American Telecommunications Certification Body Inc.
6731 Whittier Ave, McLean, VA 22101

RE: Kyocera Wireless Corp.

FCC ID: OVFKWC-K24B

After a review of the submitted information, I have a few comments on the above referenced Application. Depending on your responses, kindly understand there may be additional comments.

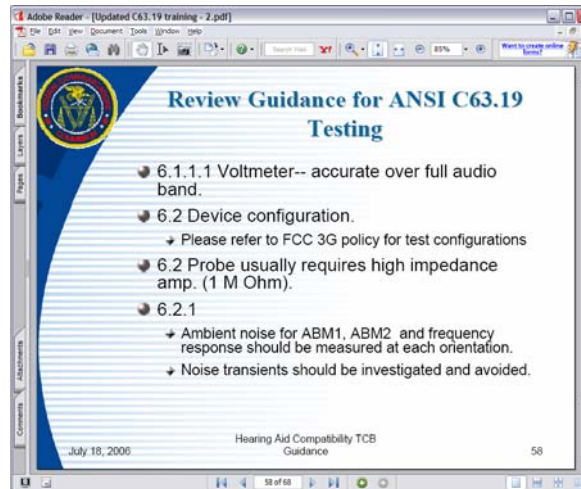
- 11) Page 41 does not define the worse case channel reported as implied.

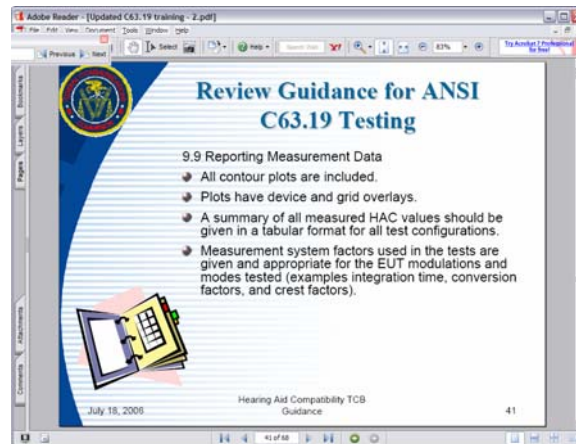
- 12) Although ANSI C63.19 7.3.2 asks only for the axial frequency response, the FCC appears to desire all 3 orientations to be measured (see below). This appears to be for the Validation setup. However given limits are specified in section 7.3.2 are only specified for axial, we have a pending question with the FCC in effort to confirm this issue.

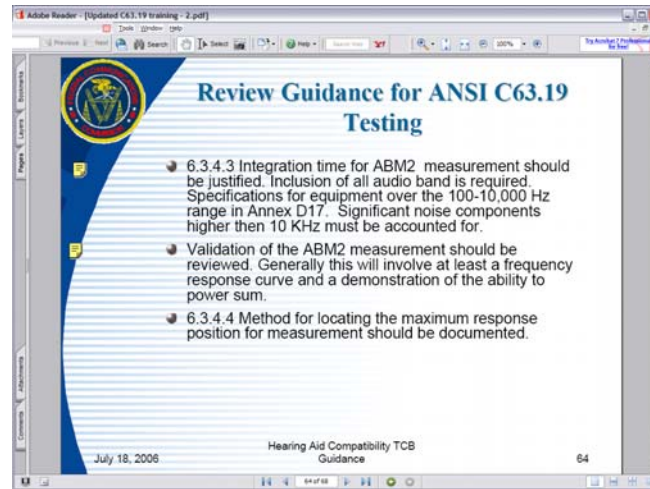
- 16) Volume setting should be documented.
- 17) It is uncertain if a sine wave or P.50 test signal was used. If a sine wave signal was used, it is uncertain how the voice coder will handle it (i.e. assurance that it will pass CW correctly). Also some base station simulators require a special vocoder calibration. If so, calibration details should be provided and clear. If a P.50 signal was used, this generally requires integration over time because of the variation of amplitude over time. Information regarding proper time lengths should be provided.
- 18) Use of multiple signal types for the different measurements should be clearly documented and justified. Example 1 KHz CW for ABM1 per 6.3 procedure, and P50 for frequency response per 6.4. Currently the specific signal types actually used (vs. a generic procedure) could not be determined.

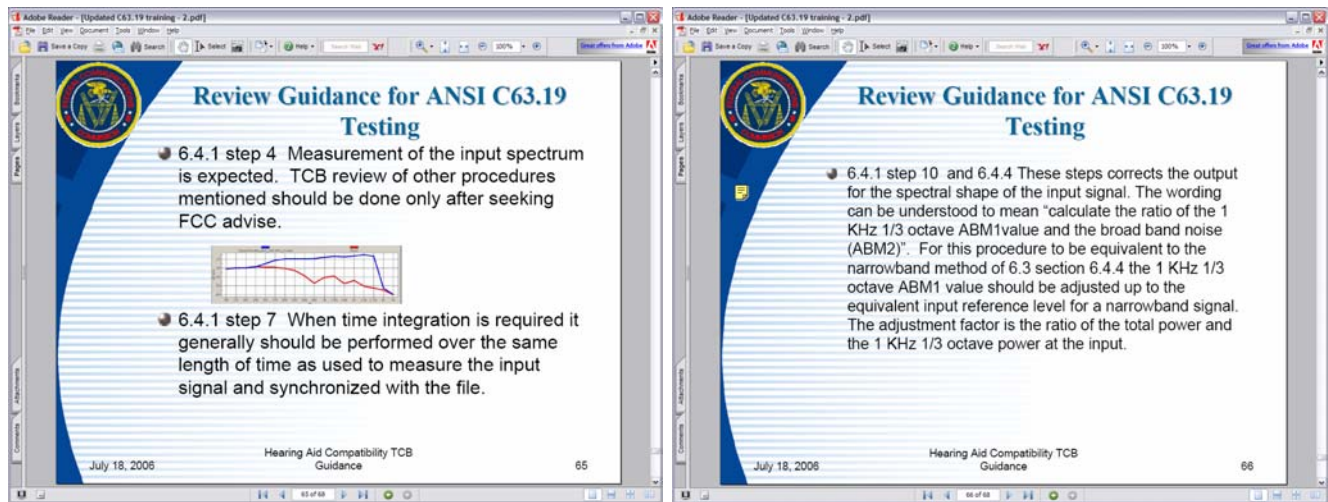
- 19) For ABM2 measurements, please justify integration times used and ensure inclusion of the whole audio band. Additionally, please help address the FCC's concern with "demonstration of the ability to power sum as cited below".

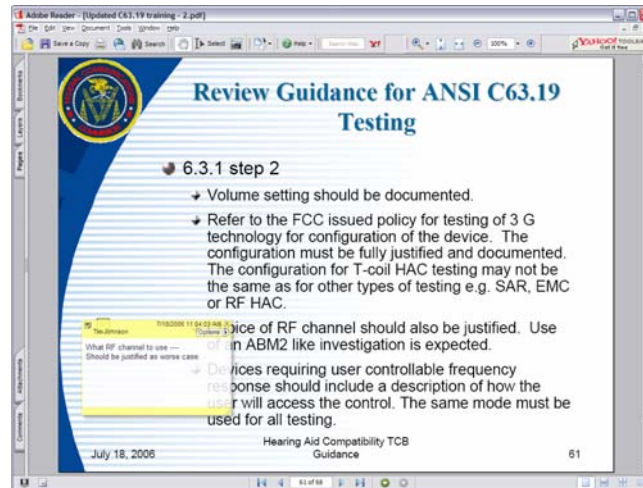
- 20) It is uncertain if measurements under section 6.4 were used. If so, the FCC has specific concerns, such as the input should be directly measured (FCC Desires measured, not calculated). If not we are told we must consult with the FCC for further information. Please explain.
